REMARKS/ARGUMENTS

Dated: March 18, 2008

Fig. 1

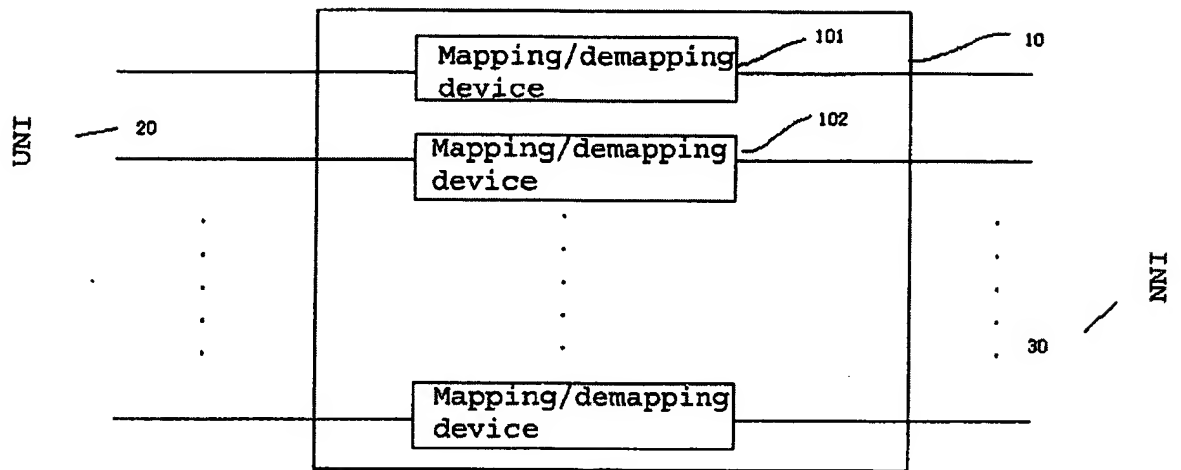
In the office action (page 2), the drawings stands objected to for not being designated by a legend such as --Prior Art--. In response, a replacement sheet with FIGS. 1, 2A, 2B, and 3 designated --Prior Art-- and an annotated drawing sheet is attached hereto on a separate page.

Fig.4(F)

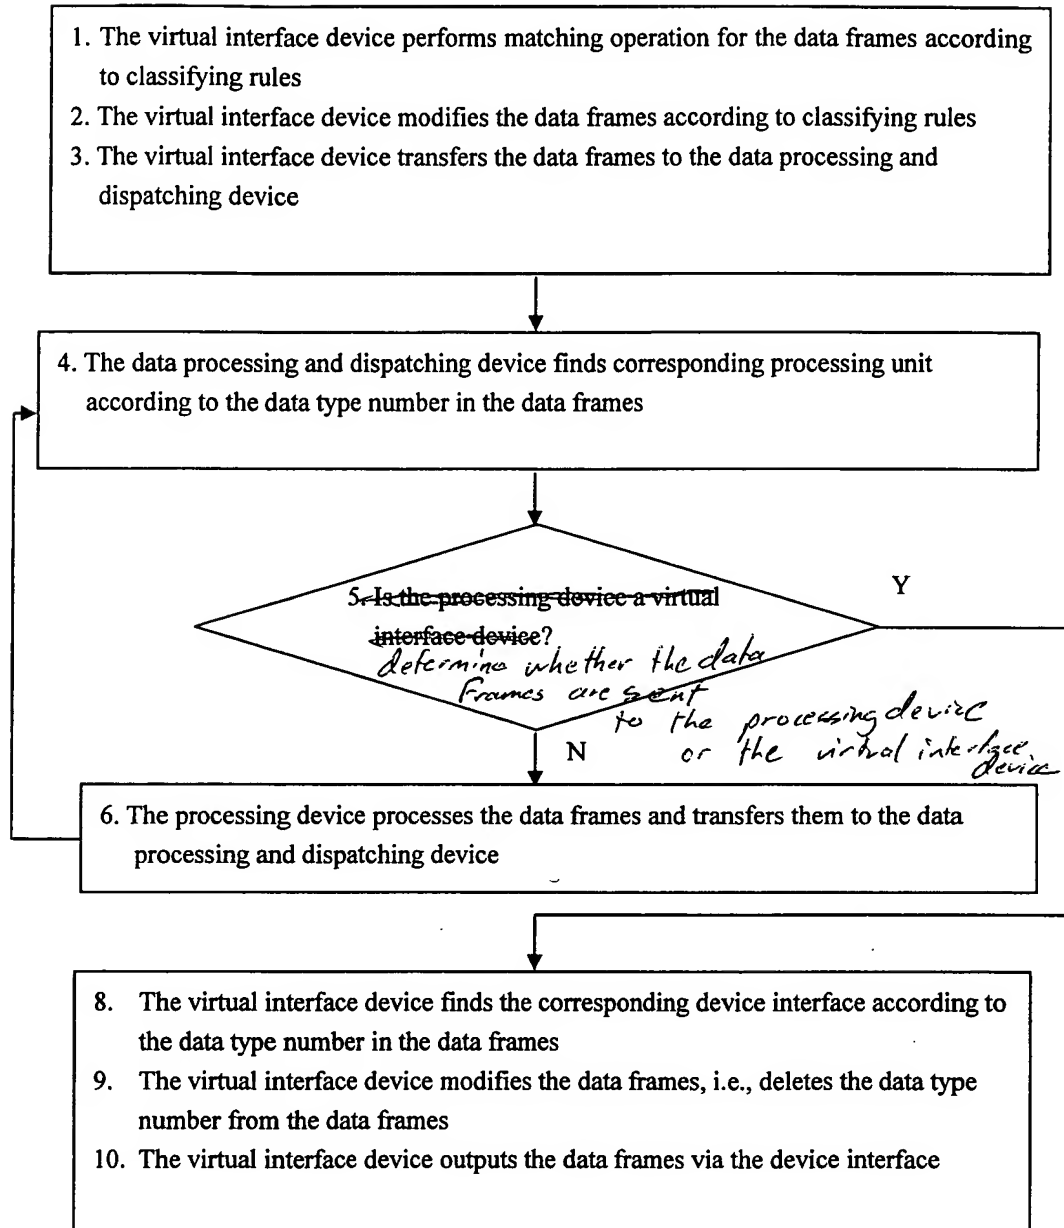
In the office action (page 2), FIG. 4 stands objected to for failing to show a plurality of virtual private devices 120 as described in the specification [0057]. In response, [0057], [0094], and [0160] of the specification have been amended based on FIG. 4, i.e. the system includes a virtual private device 120. Accordingly, the applicants respectfully request withdrawal of the objection.

According to the flowchart of FIG. 4(F), the data processing and dispatching device can process data frames in two directions, i.e., from or to a processing device (including the virtual bridge device, the virtual private device and the RPR device). In particular, in FIG. 4(F), the data processing and dispatching device finds a processing device (e.g. the virtual bridge device) according to the data type number in the data frames in step 4; and it is determined whether the data frames are sent to the processing device or the virtual interface device in step 5; if the data frames are sent to the processing device, the data frames are processed by the processing device and transferred to the data processing and dispatching device in step 6; if the data frames

are sent to the virtual interface device, the data frames are output to a device interface (e.g. UNI or NNI) in step 8.
